R4B Supplementary Design Statement for S4.55 MOD

ONE SYDNEY HARBOUR

R4B SUPPLEMENTARY DESIGN STATEMENT FOR S4.55 MODIFICATION APPLICATION June 2022

R4B Ground Floor Plan - Proposed

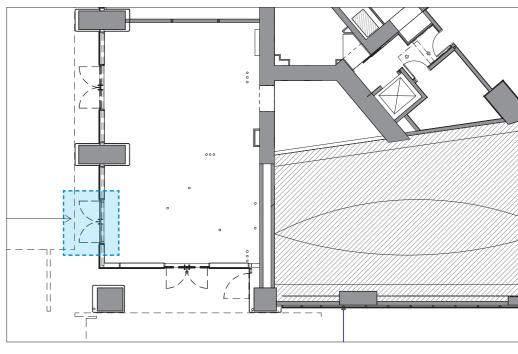
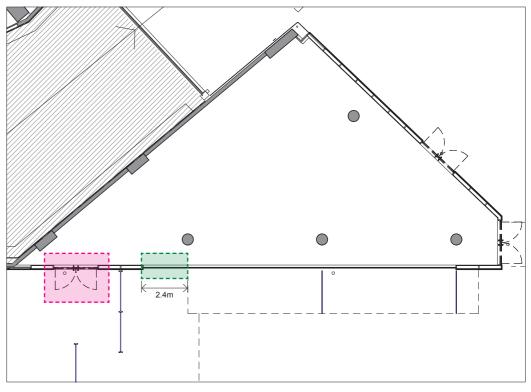
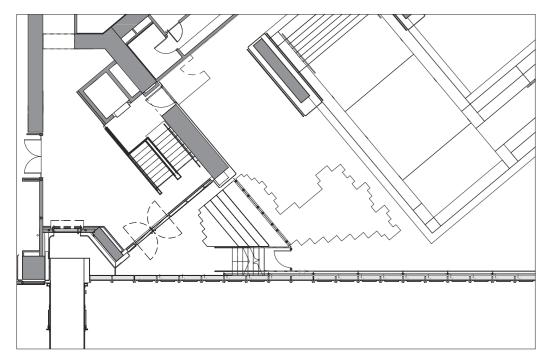
Minor changes are proposed for the ground floor retail doors. These changes are predominantly a response to a more developed retail brief which seeks to create a highly activated ground floor plane that promotes public safety and provides a high degree of civic amenity.

Extension of bi-fold door system

Additional double doors facing the park

Single door changed to a double door to enable better and safer access to the retail from the Strada

R4B Level P02 Plan - Proposed

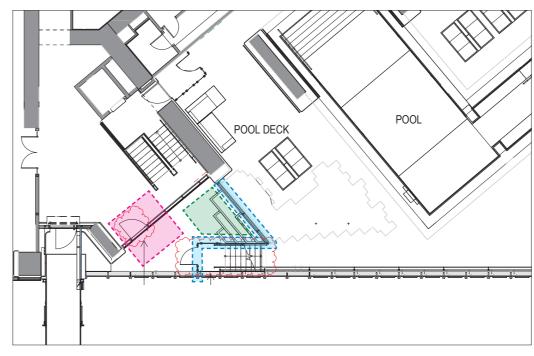
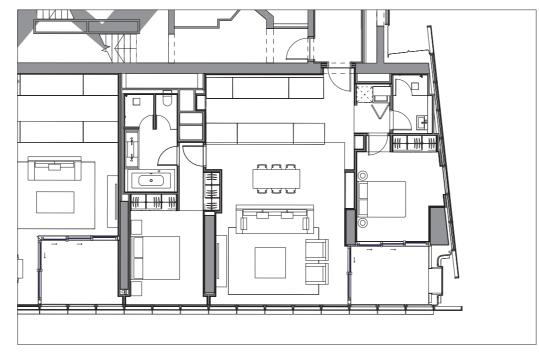
In order to comply with AS 1926.1-2012 'Safety barriers for swimming pools' it was deemed necessary to relocate the swimming pool enclosure gate to the lower external terrace above the Strada. This was due to the fact that the stair handrails and some of the elements within the adjacent PL-03 podium facade parapet could not be removed from the non-climbable zones (NCR) that are required under AS 1926.1-2012.

Responding to these constraints, the design team has revised the design so that the gate is relocated to the bottom of the steps. This results in a compliant solution under AS 1926.1-2012 but it also serves to conceal the gate and the associated hardware from view when standing or seated on the main pool terrace.

This change presented an opportunity to reconsider the materiality of the terraced garden beds. Whereas in the approved design the planter boxes were to be fabricated out of painted steel, the proposed design is for these to now be fabricated out of concrete blockwork walls that will be faced in the same travertine that is used extensively on the external terraces. This is an important design change that is more consistent with the concept of an eroded stone landscape that cascades down to the main terrace access point.

Updated pool fence and gate arrangement

Revised single door

Updated terraced landscape form and materiality

R4B Floor Plan for Levels 48-63 - Proposed

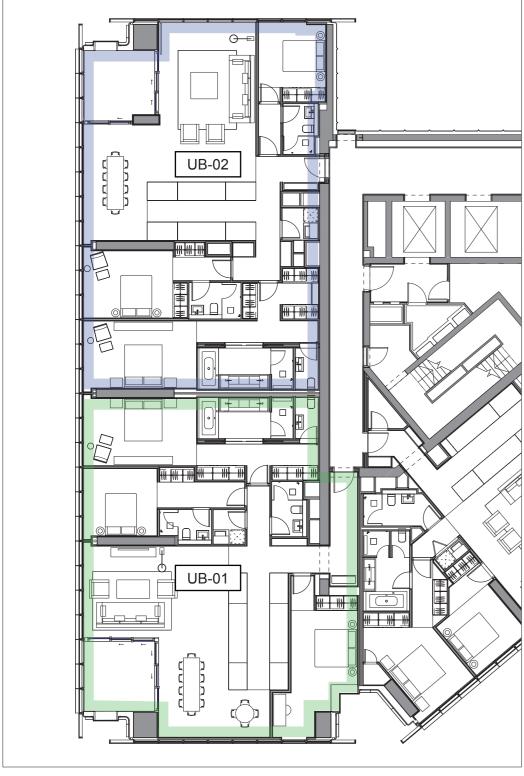
A slight amendment of the home automation cupboard is proposed for apartment type UB-03 on levels 48-63 in order to provide adequate space for home automation away from the apartment distribution board.

R4B Floor Plan for Level 59 - Proposed

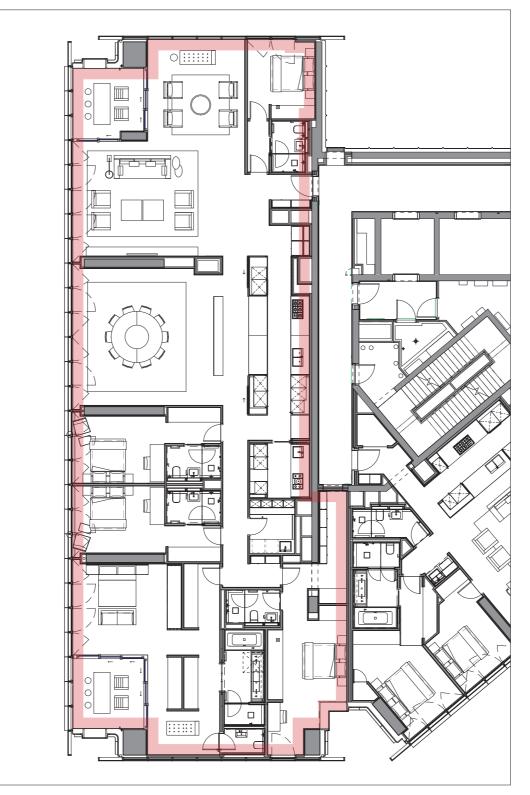
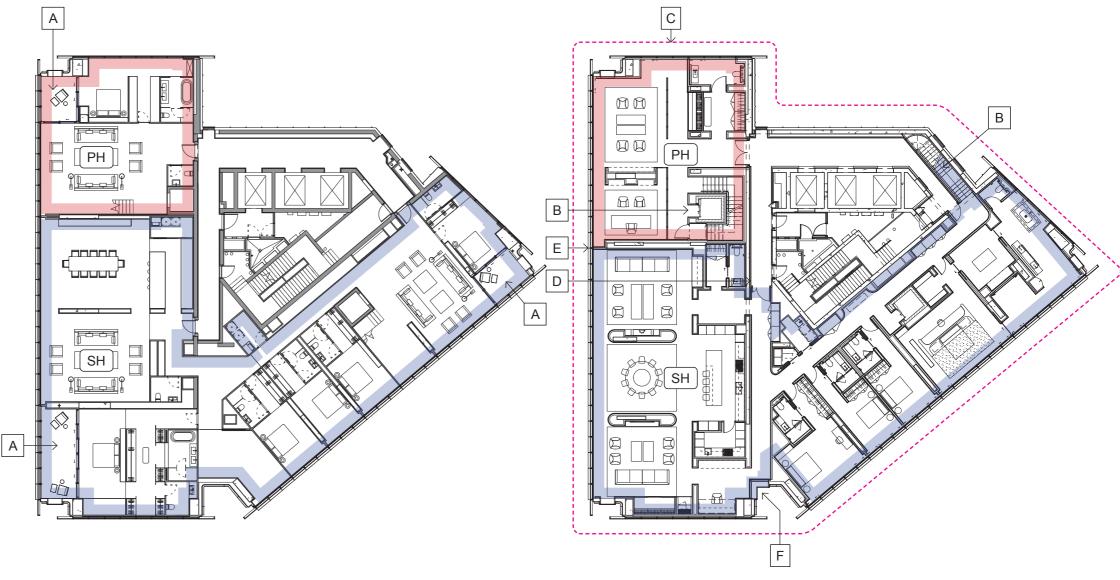
Development consent through this modification is requested for the amalgamation of two 3 bedroom apartments (UB-01 and UB-02) on Level 59 in order to create one large 5 bedroom apartment. This change is proposed in order to meet market demand for a larger apartment. The addition of this 5 bedroom apartment will serve to further diversify the apartment mix within the development.

R4B Floor Plan for Level 64 - Proposed

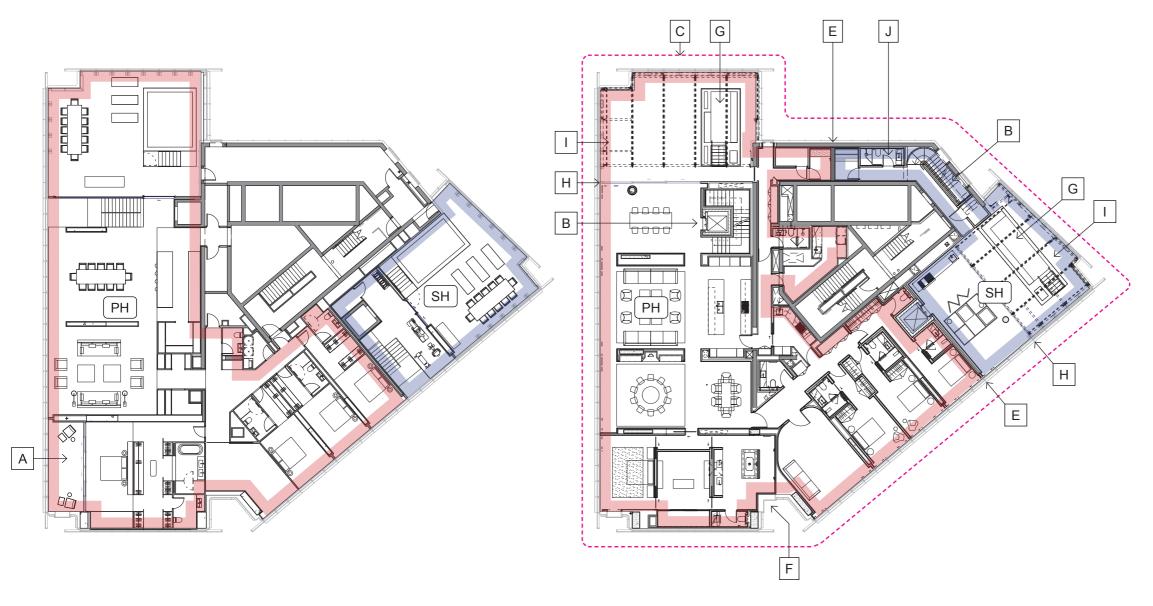
The changes to the lower level of the Penthouse and Skyhome apartments include:

- A. Deletion of the wintergardens (refer to Section 4.1)
- B. Revised lift and stair locations
- C. Revised floor plan layout
- D. Revised 'Skyhome' main entry location
- E. Revised location of inter-tenancy partition wall
- F. Introduction of a 'notch' window

Revised apartment layout

R4B Floor Plan for Level 65 - Proposed

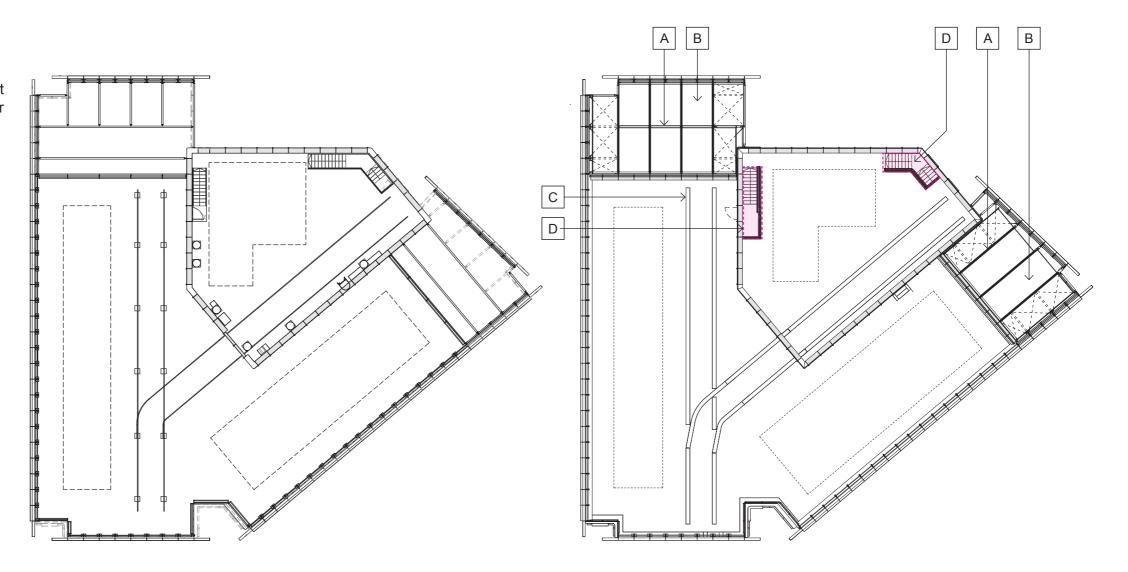
The changes to the upper level of the Penthouse and Skyhome apartments include:

- A. Deletion of the wintergarden (refer to Section 4.1)
- B. Revised lift and stair locations
- C. Revised floor plan layout
- E. Revised location of inter-tenancy partition wall
- F. Introduction of a 'notch' window
- G. Reconfigured external terrace and pool
- H. Reduction in the width of the external terraces by 1 facade module in the Penthouse and 2 facade modules in the Skyhome
- I. Revised steelwork and overhead shading (refer to section 3.5)
- J. Utilisation of former 'back of house' space for the provision of further amenity for the residents

R4B Rooftop Floor Plan - Proposed

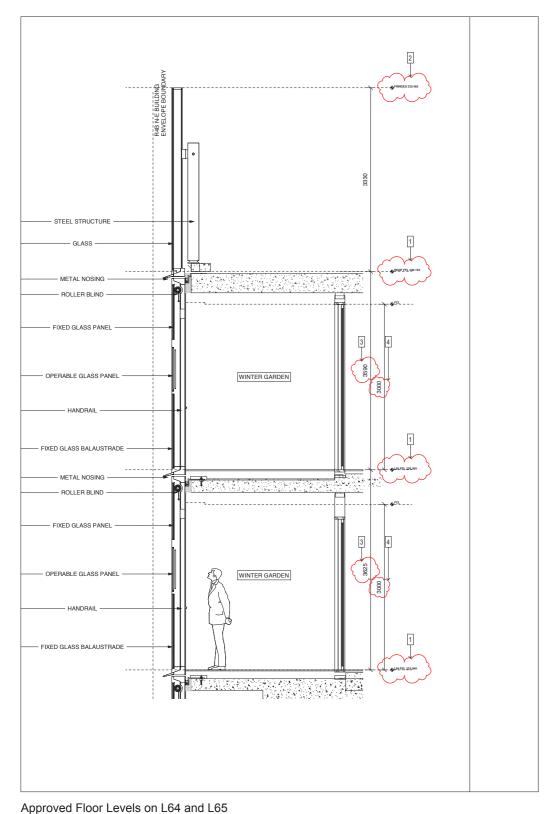
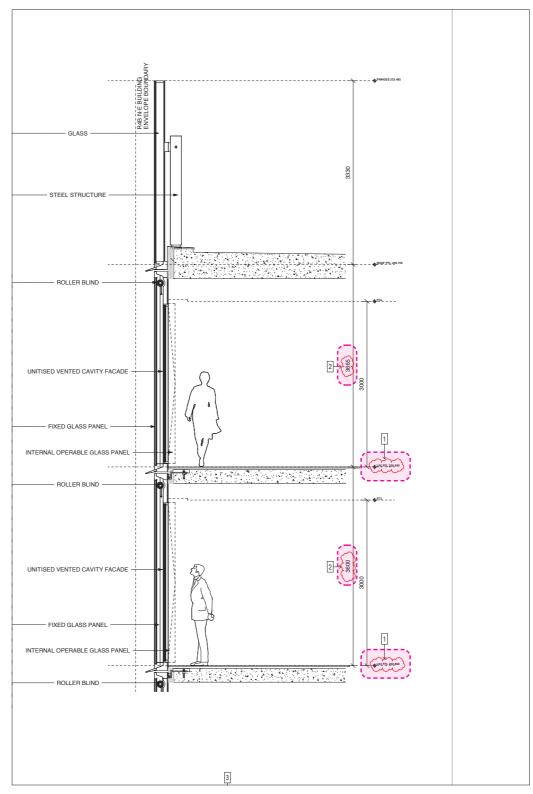
The changes to the rooftop layout include:

- A. Refinement of the double height steelwork design
- B. Refinement of the sun shading above L65 terraces
- C. Refinement of the BMU rails and parking location
- D. Revised upper roof stairwell voids

Proposed Floor Levels on L64 and L65

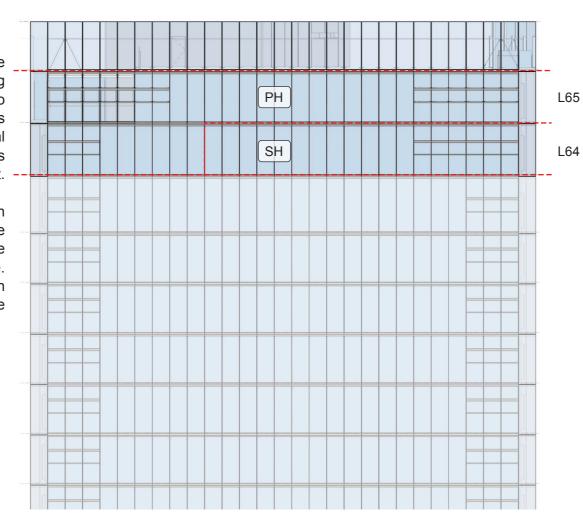
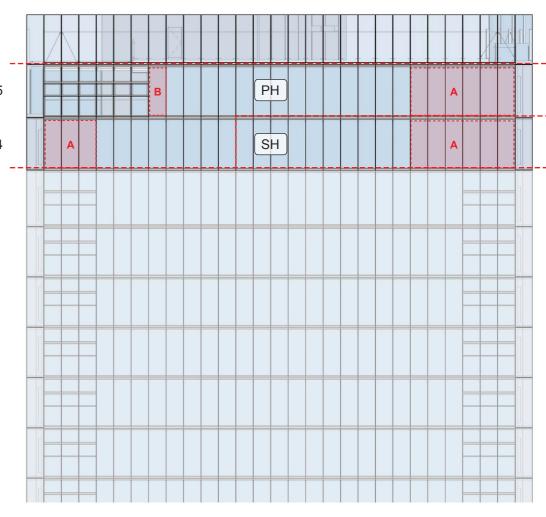
As part of the design development of the Penthouse and Skyhome apartments, the floor to floor heights of levels 64 and 65 are proposed to be slightly amended. As part of this change, the finished floor level of L64 has been lowered by 50mm without any impact to the ceiling height of L63 below.

Revised levels
